TSG-RAN WG3 meeting #7
Sophia Antipolis, 20-24 September 1999

TSGR3#7(99)C37

Title: UMTS 25.427: Iur/Iub User plane protocol for DCH data streams, v.0.4.2
– Editor's proposal

This document contains an editor's proposal for changes in TS25.427. Revisions show the changes respect to the version 0.4.1, submitted to WG3#7.

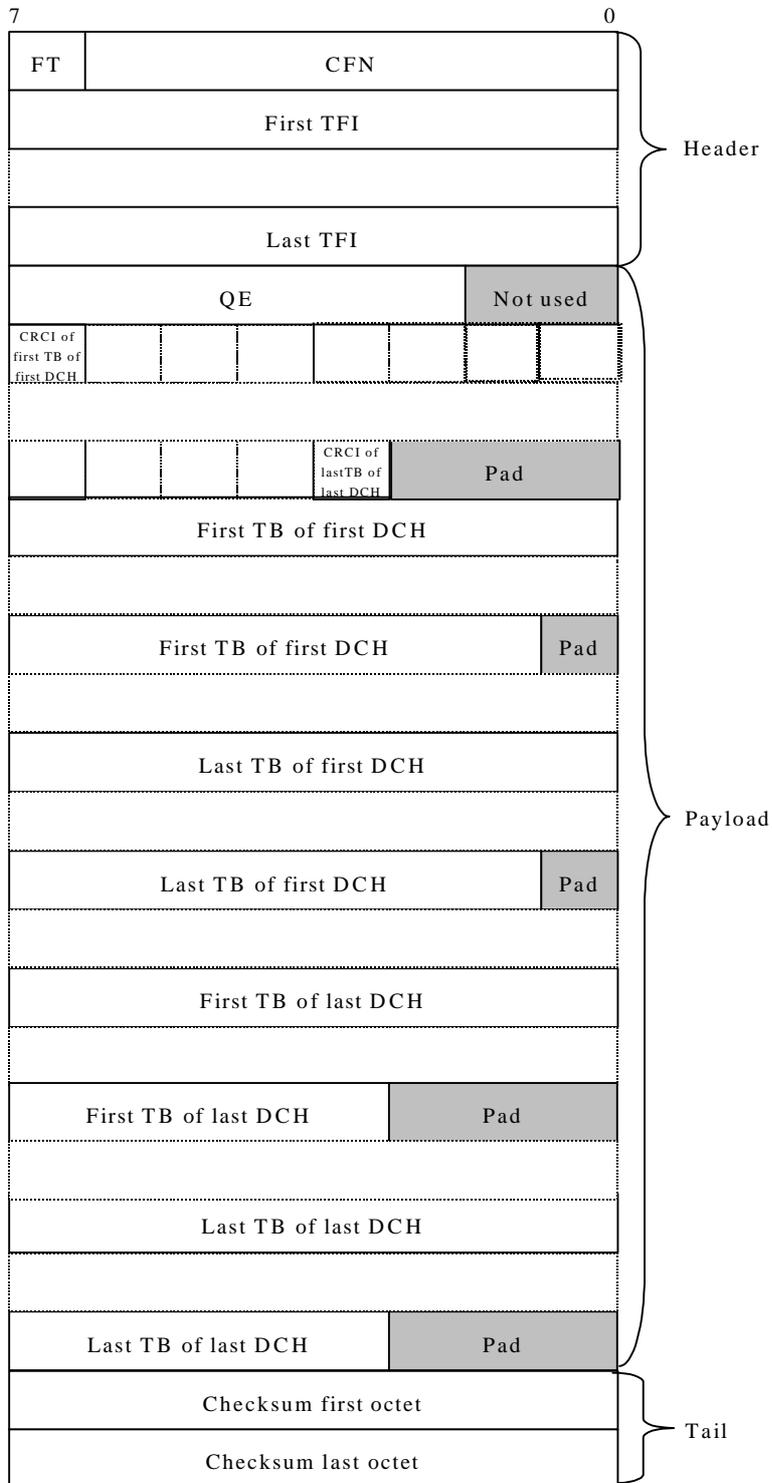
The use of separate checksums for the header and the payload is a working assumption.

7.1.2 Downlink data frame

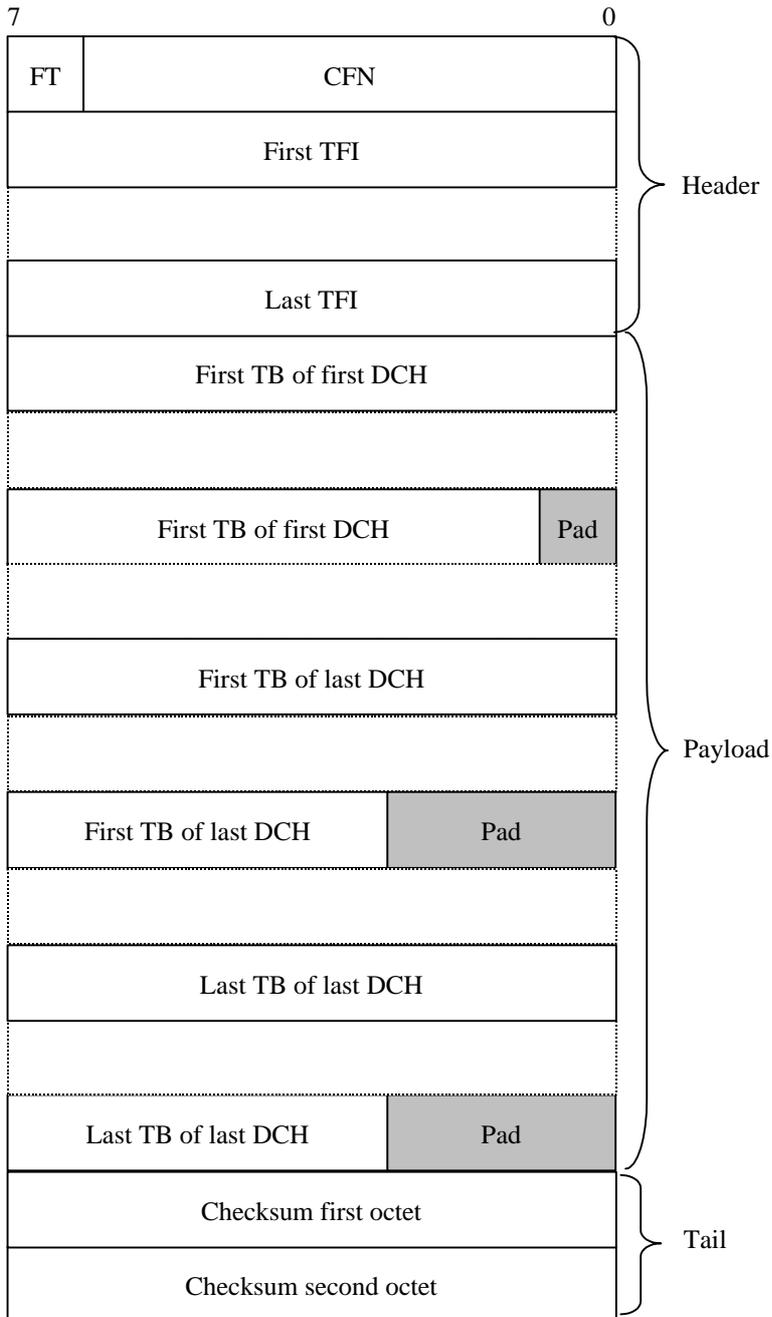
The structure of the UL data frame is shown below. The handling of 8 bits CFN is FFS.

Editor's note: the structure is not in line with the current length of the CFN (8 bits). The structure of the header shall be redefined.

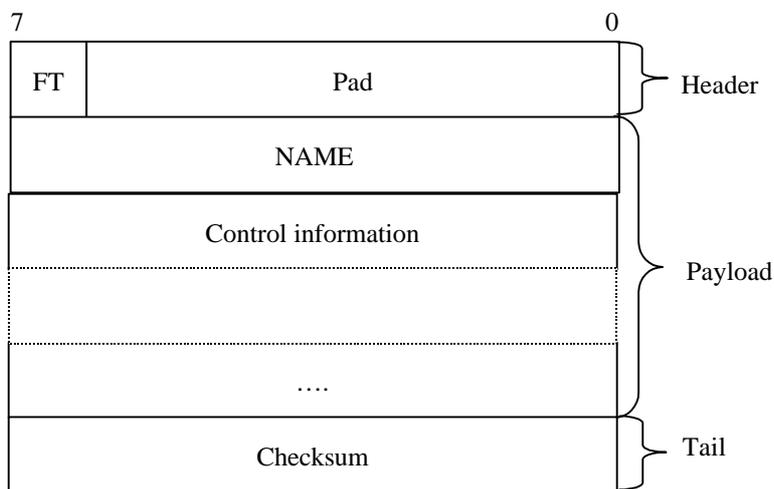
The structure of the control frames is shown in the figure below:

Note: the length and definition of the Checksum field is FFS.

Figure X. “Channel”DCH Node Synchronization procedure.

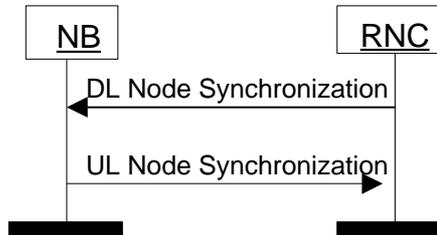
In the Node Synchronization procedure, the SRNC sends a DL Node Synchronization control frame to Node B. Upon reception of a DL Synchronization control frame, the Node B shall respond with UL Synchronization Control Frame, indicating t2 and t3, as well as t1 which was indicated in the initiating DL Node Synchronization control frame.

[Editor's Note: modification accordingly to comments from Ericsson on the reflector.](#)
